**TB 140**

## **SAFETY BULLETIN**

Product: Midilift XLplus

**Subject:** Incident: Electric hoist clash with counterweight

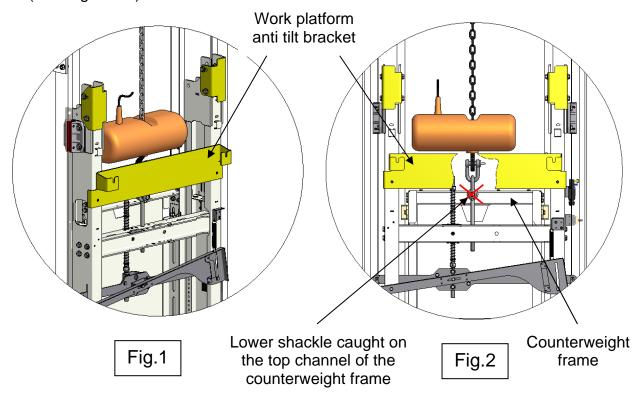
This bulletin relates to the installation stage of the Midilift XL+. When the electric hoist is being used to raise the sling and work platforms a potential hazard has been reported as a near miss.

It was reported that when driving the sling upwards, the shackle connecting the hoist to the sling caught the top of the counterweight frame. This resulted in the counterweight assembly rising with the sling until becoming dislodged and then falling onto the buffer. (See Fig.1 & .2)

To avoid this reoccurring, an additional bracket has been added to the counterweight assembly to cover up the top channel, this bracket will eliminate the possibility of the D-shackle catching and raising the counterweight frame.

The work platform anti tilt bracket has also been modified as it was found that this bracket clashed with the hoist, forcing two D-shackles to be used to raise the hoist above the bracket. The new anti tilt brackets (one each side of the sling) enable a single D-shackle to be used to connect the hoist to the sling.

As a further precaution, ensure that the eyebolt is attached at its maximum height and also that the D-shackle is orientated so that it is parallel to the counterweight, with the shackle in this position it will be impossible for there to be any clashes with the counterweight. (See Fig.3 & .4)
